AN APPRAISAL OF THE 1992 PRELIMINARY PERFORMANCE ASSESSMENT FOR THE WASTE ISOLATION PILOT PLANT

Environmental Evaluation Group
New Mexico

September 1994

This is the Environmental Evaluation Group's (EEG) appraisal of the 1992 performance assessment for the Waste Isolation Pilot Plant. Performance assessments have been performed by Sandia National Laboratories for the U. S. Department of Energy to predict the long-term safety of the Waste Isolation Pilot Plant. The 1992 Performance Assessment, entitled *Preliminary Performance Assessment for the Waste Isolation Pilot Plant, December 1992,* is in five volumes:

Figure 13. Distribution of initial Reynolds numbers in CUTTINGS vectors.

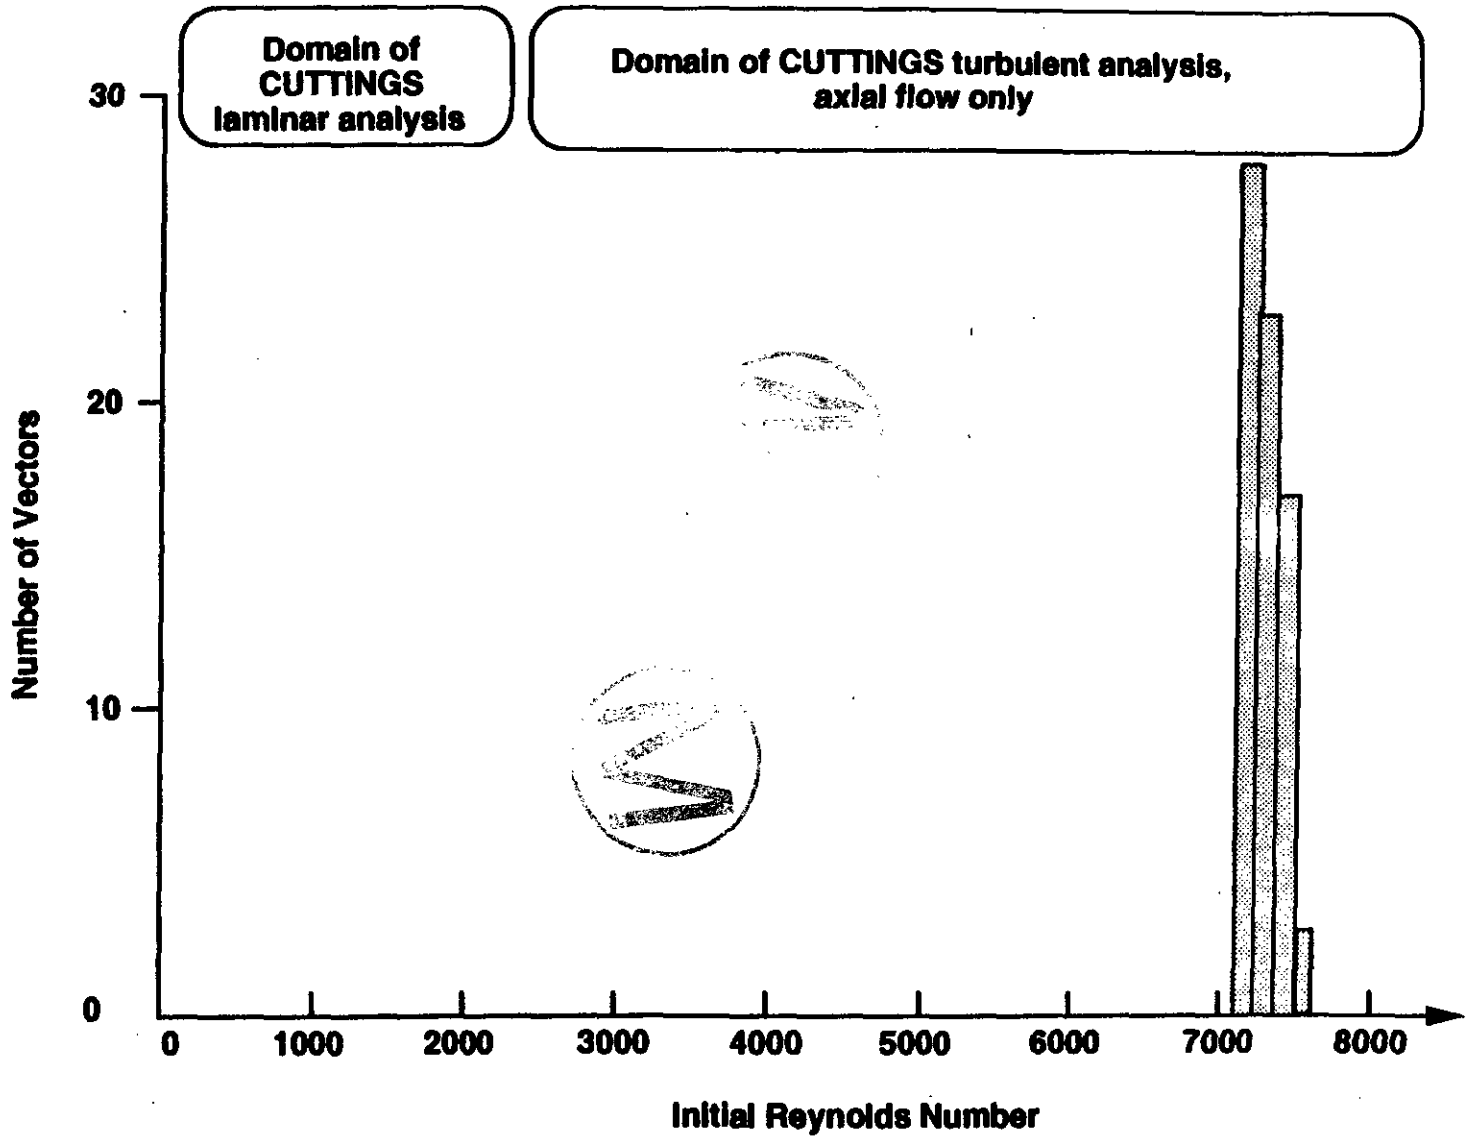
EEG has examined the initial Reynolds numbers in the 70 vectors of CUTTINGS analysis for the *1992 Performance Assessment*. The distribution of these initial Reynolds numbers is shown in Figure 13. The mean of these initial Reynolds numbers is 7334 and the standard deviation is 87. These initial Reynolds numbers are well above the range for laminar flow. The analysis for erosion by laminar flow may be elegant, but it appears to be irrelevant. The exclusion of erosion by helical turbulent flow and the effect of sediment erosion is non-conservative.

12.2 In the *1992 Performance Assessment*, the program CUTTINGS analyzes only the E2 scenario. The E1E2 scenario was not analyzed. This was not stated in the *1992 Performance Assessment*.

Recommendation 12. Future performance assessments need to include erosion of waste by helical turbulent flow and the effect of sediment erosion. Also needed is analysis of other relevant scenarios, such as E1E2 and brine slurry discharge to the surface.

Figure 14. Radioactivity levels in standard waste boxes calculated by EEG and SNL.

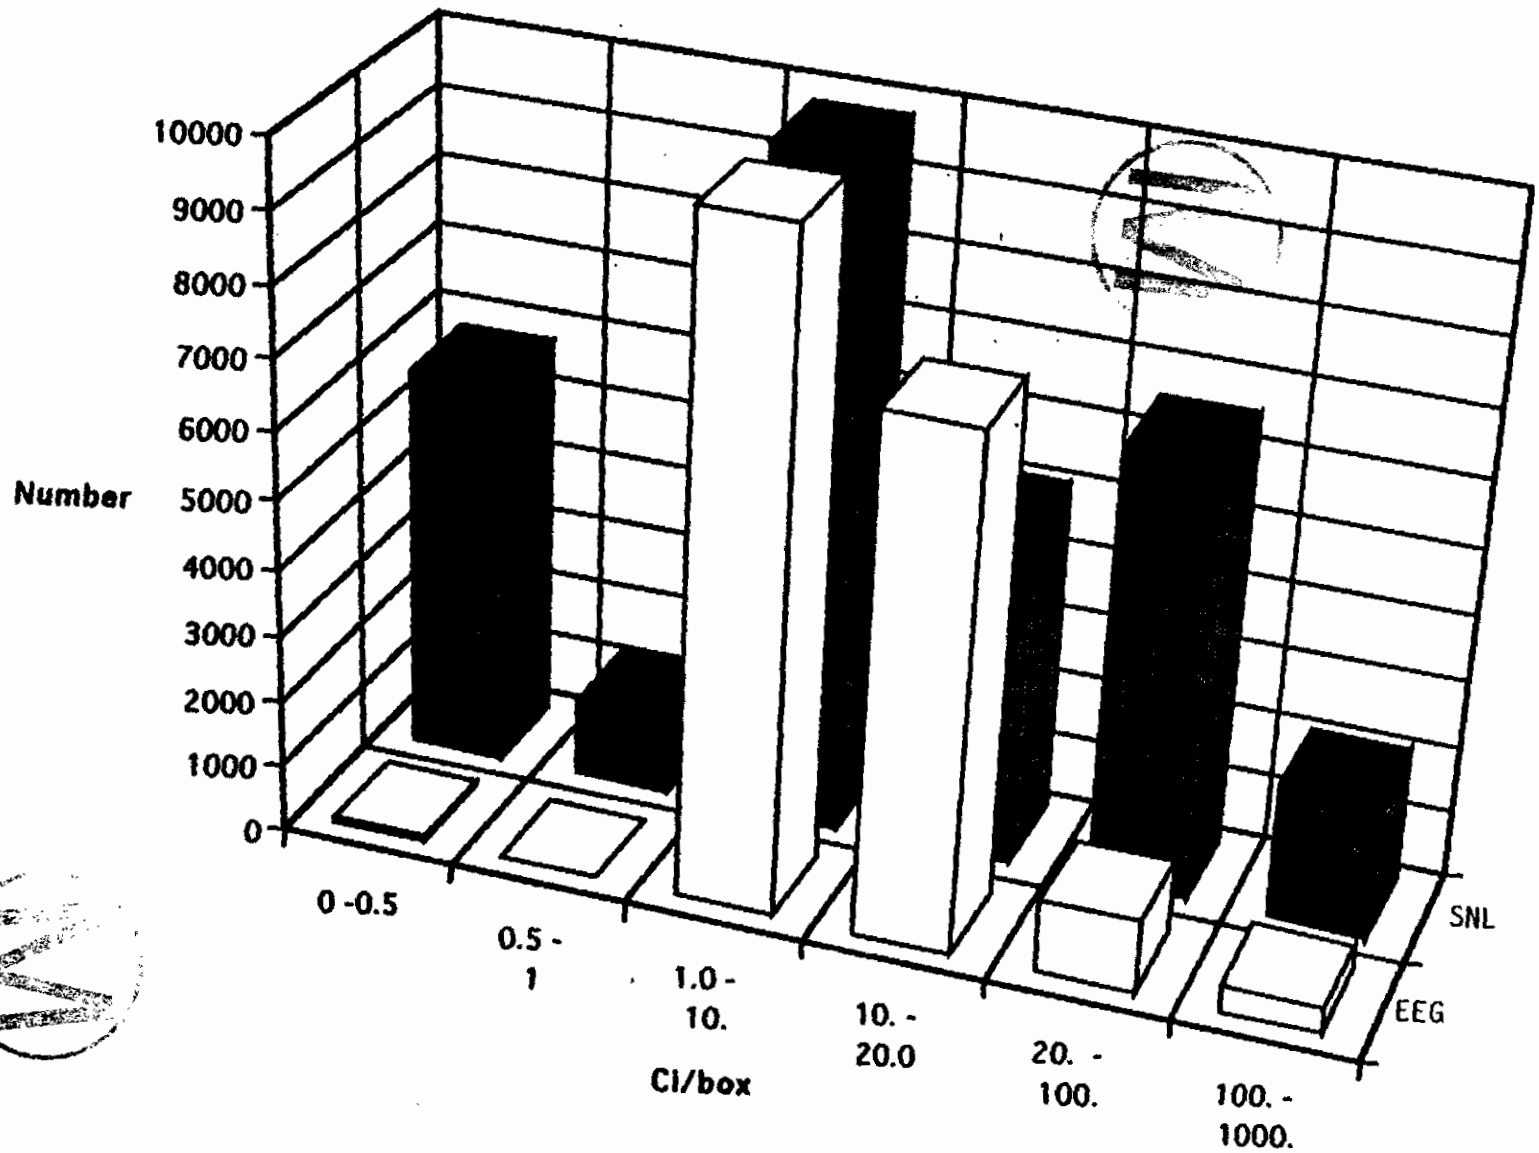
13.2 The *1992 Performance Assessment* used five activity levels for contact-handled TRU waste. The cited source is a SNL internal memo by Peterson [vol. 3, Appendix A, pp. A-135-140]. It is not possible to reproduce the results. Using data from input to the 1991 *Integrated Data Base*, (USDOE 1991b), we compare our results for categorizing contact-handled standard waste boxes against Peterson's in Figure 14. It is obvious the two do not match. SNL needs to explain how the results were obtained. The memo by Peterson was dated October 28, 1992, well after most of the computations for the *1992 Performance Assessment* had been completed. SNL should explain what inventory was actually used in calculations.

Recommendation 13.2 Show the basis for inventories used.

Figure 15. Comparison of subjectively elicited plutonium solubility and experimental solubility.

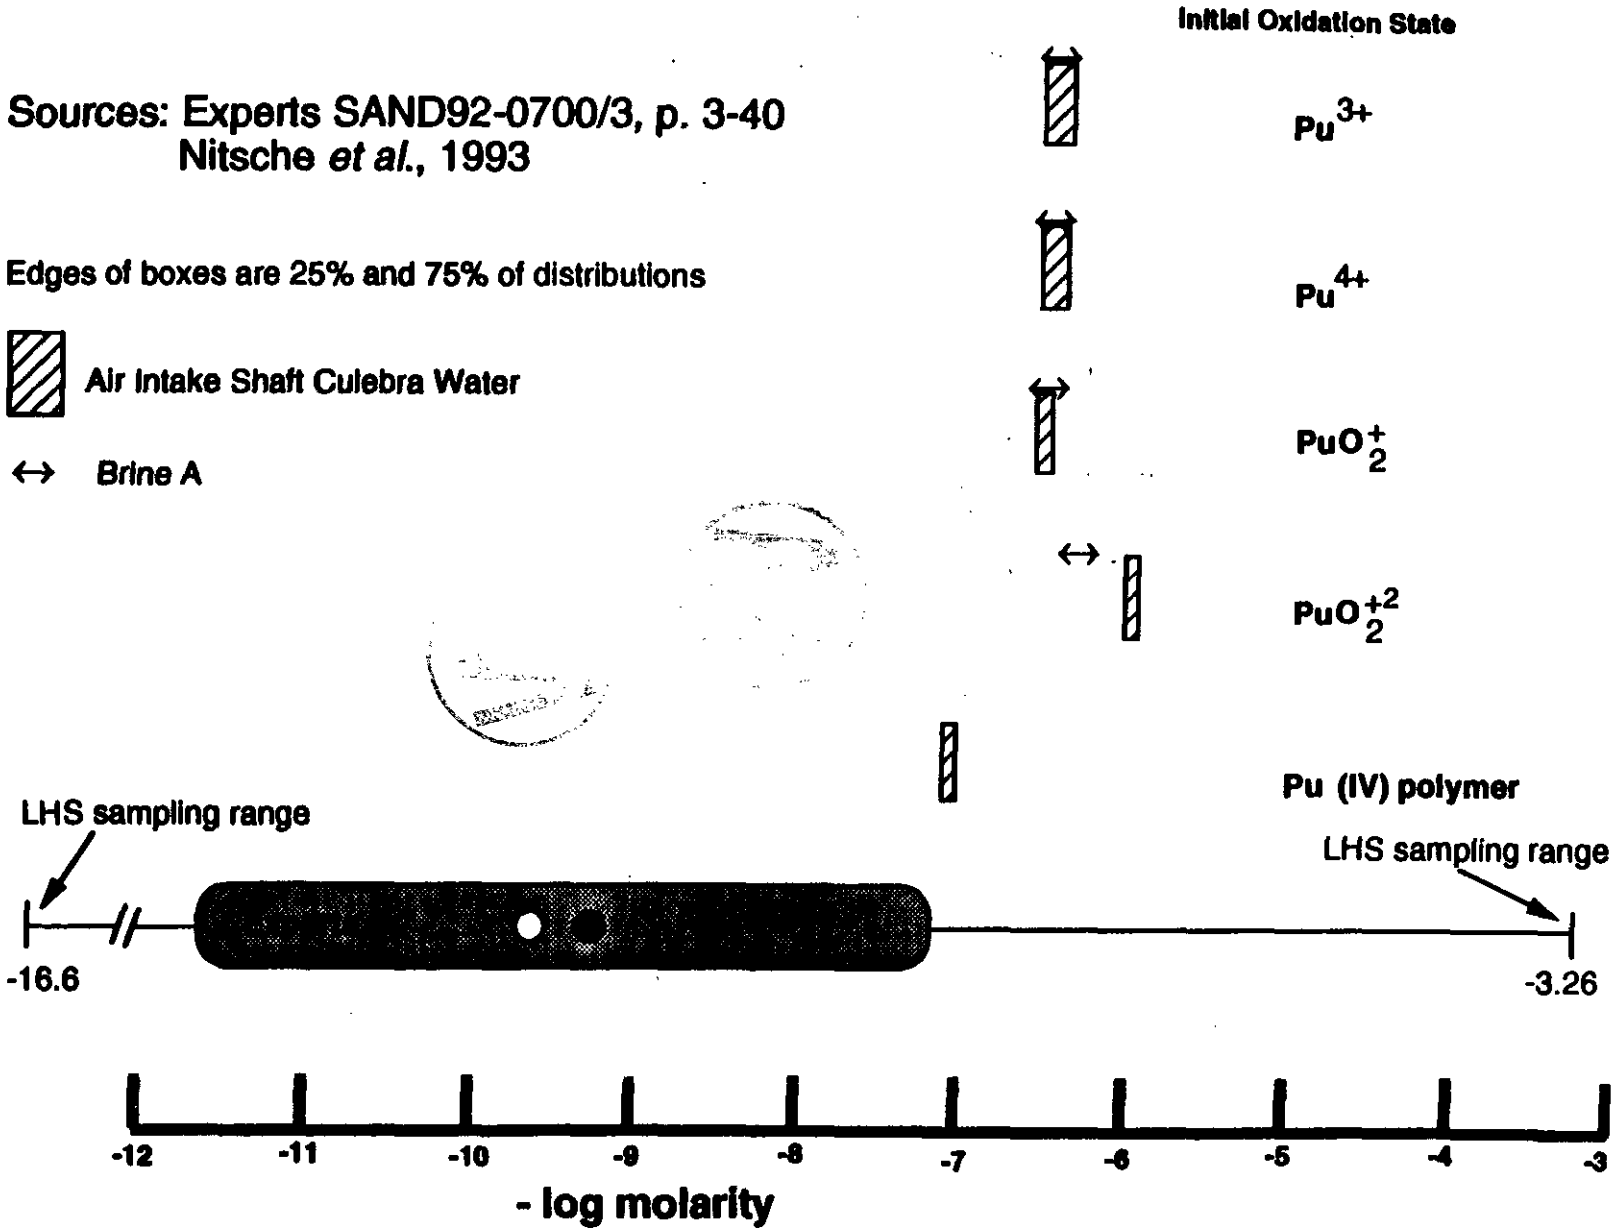
When these wide, subjective estimates are used in Latin Hypercube Sampling of input values, non-conservative solubilities in consequence calculations may result. We shall examine the case for plutonium. In the *1992 Performance Assessment*, the sampling range for plutonium solubility was 5.5×10^{-4} mole/L to 2.5×10^{-17} M [vol. 3, p. 3-40], based on subjective elicitation, as shown in Figure 15. The black circle is the median and the open circle is the mean of the elicited distribution.

Solubility measurements are available at WIPP for Culebra water from the air intake shaft (Nitsche *et al.*, 1992), and for Brine A, a simulant of brine expected to inundate the repository (Nitsche *et al.*, 1993). Nitsche's solubility measurement experiments lasted several hundred days, and were started with various oxidation states of plutonium. Results are also shown in Figure 15. For the various initial oxidation states the steady-state concentration estimates are plotted, assuming the results are normally distributed, and the 25 and 75 percentiles are the edges of the boxes or ends of the arrows. The experimentally measured solubilities are generally greater than 10^{-7} M. However, when one examines the values of plutonium solubilities used in the 70 realizations in the Monte Carlo analysis [vol. 4, p. C-10], one find

out that only 14 of the 70 realizations had a plutonium solubility of 10^{-7} M or higher, or 20%. The use of subjective elicitation apparently resulted in a downward bias in estimating plutonium solubility, leading to non-conservative consequences.
